ADDENDUM ONE

Project: **Sullivan County Immunization**

November 11, 2022

This Addendum is part of the Contract Documents for the above referenced project and modifies the original drawings and/or specifications, dated **10/27/22**, as noted below. The bidder shall acknowledge receipt of this Addendum in the place provided in the Bid Form. The published bid date and time shall remain the same.

LIGHTING PLAN - ALTERNATE BID #1

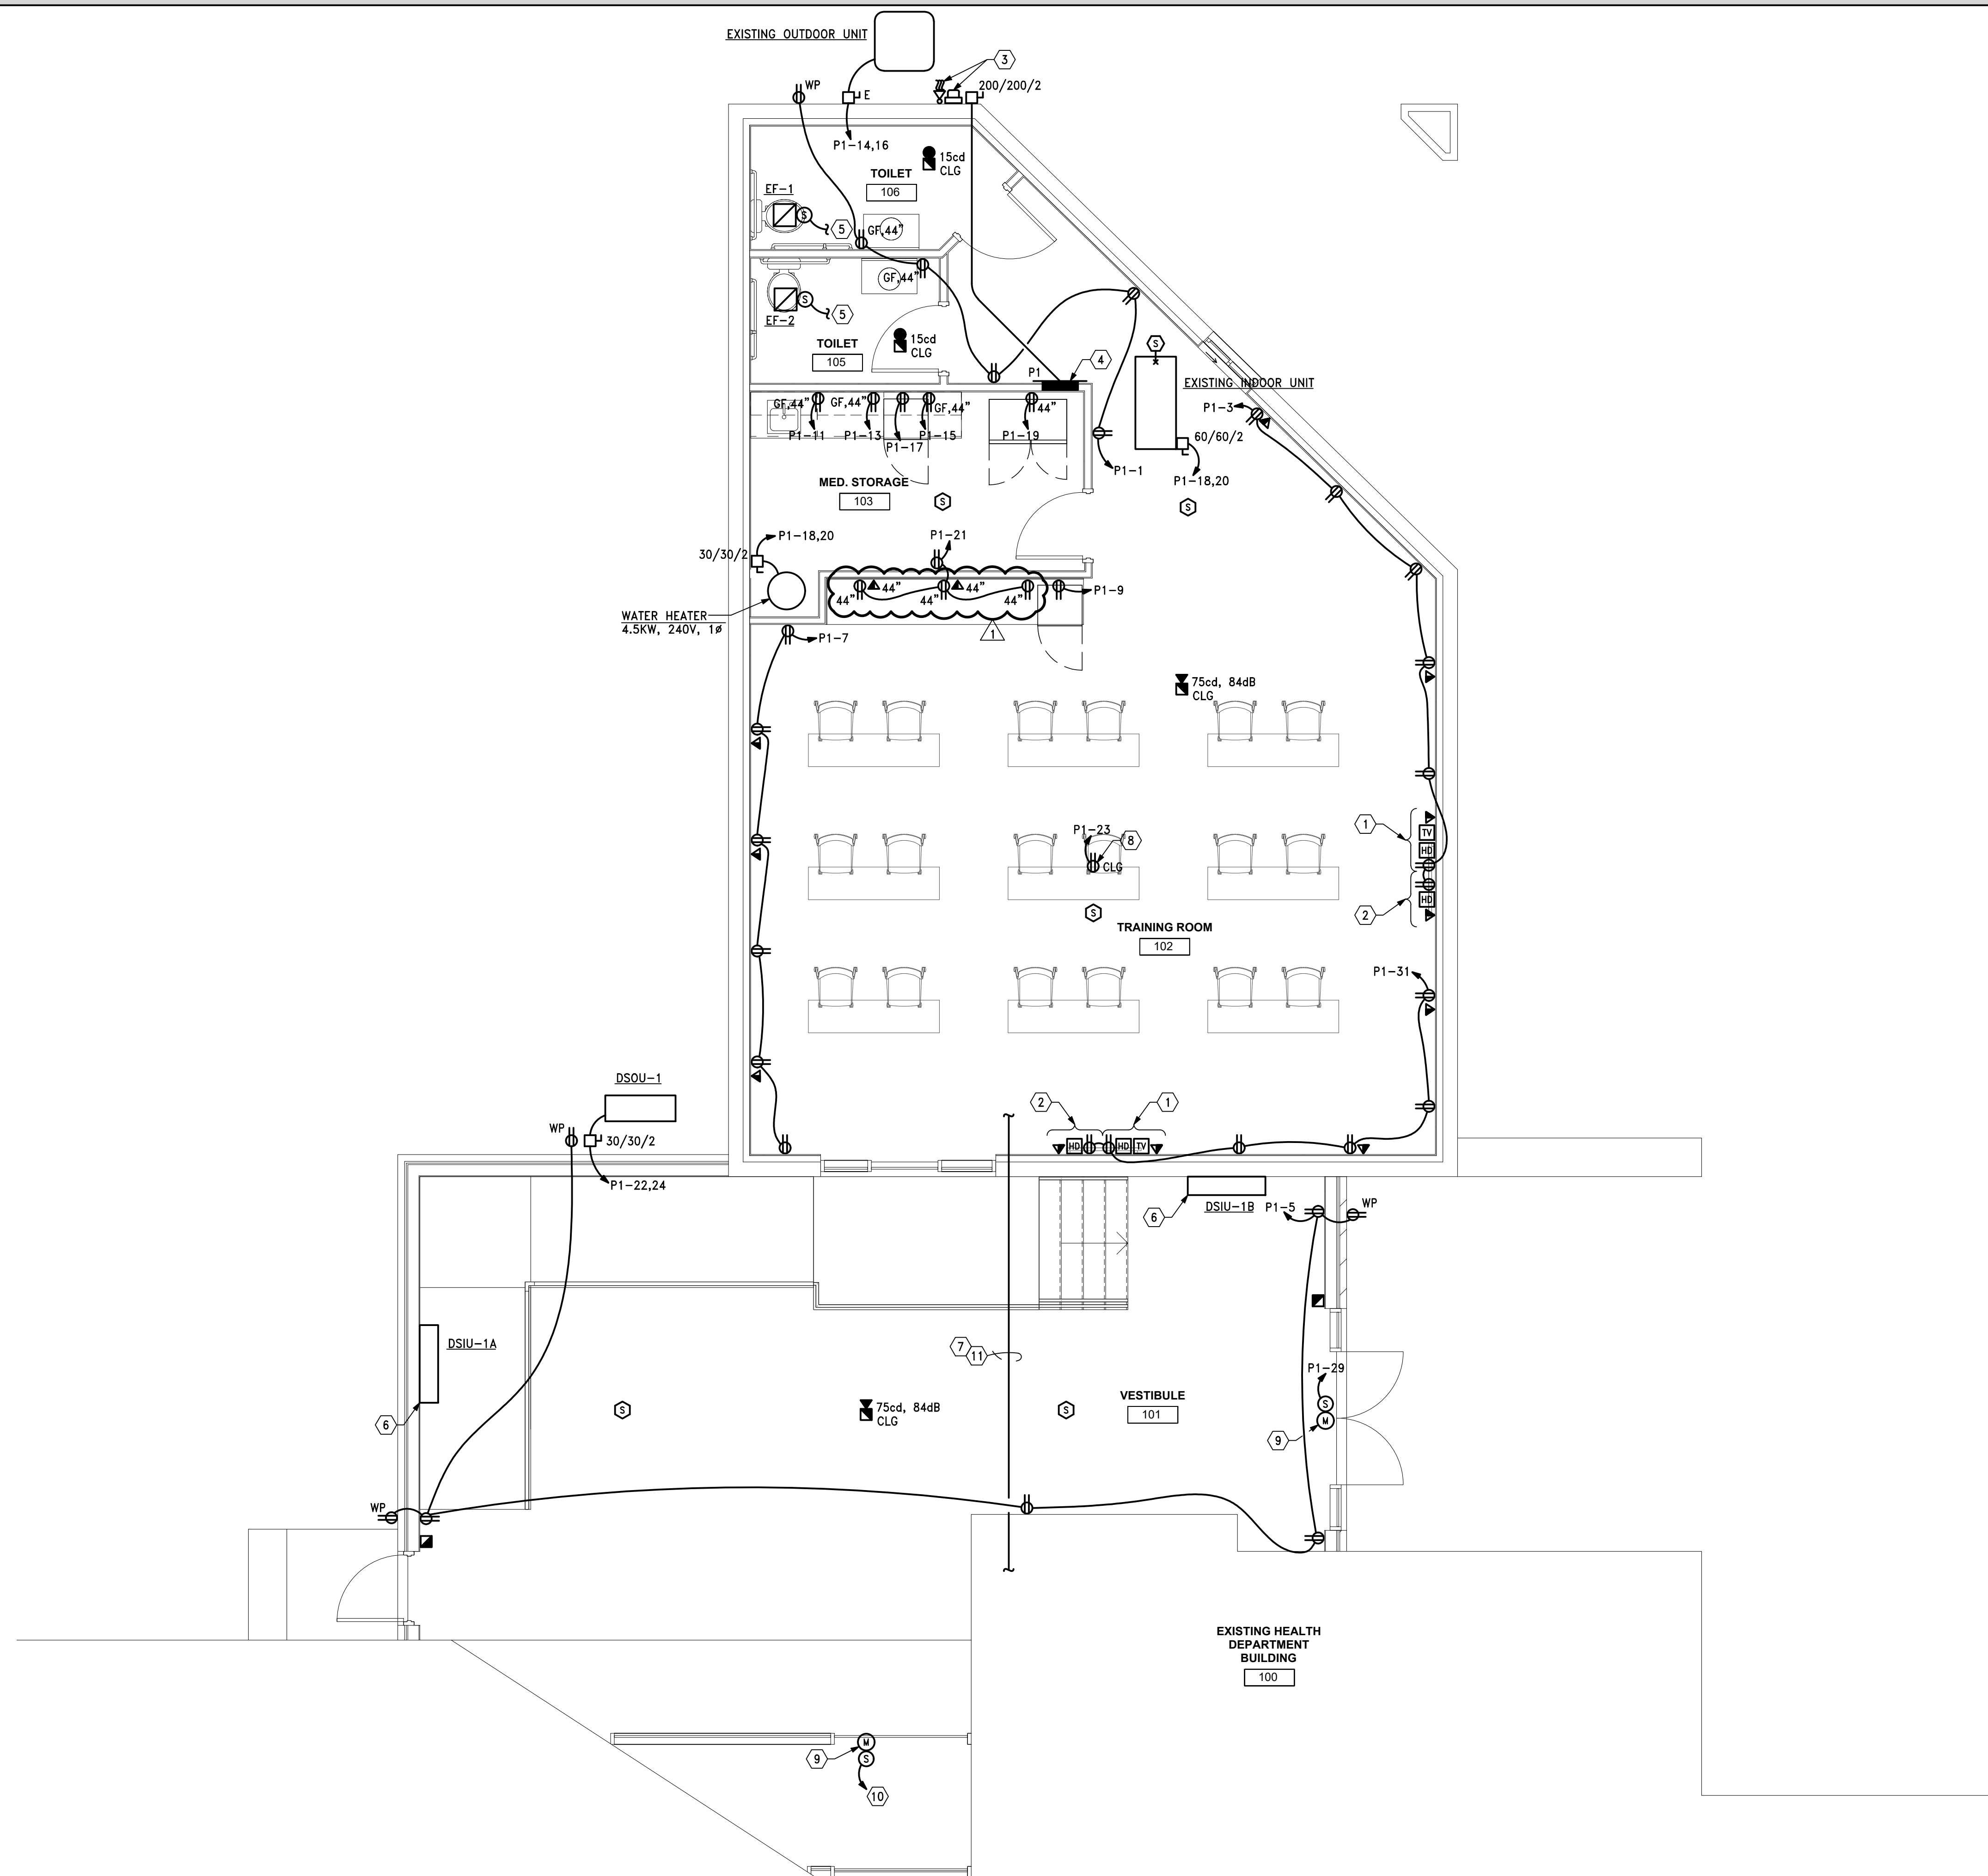
22. **Sheet E-12 Lighting Plan – Alt. 1** - added labels to canopy lights.
23. **Sheet E-21 Power Plan - Base Bid** – added casework receptacle notes.
24. **Sheet E-22 Power Plan – Alt. 1** - added casework receptacle notes.
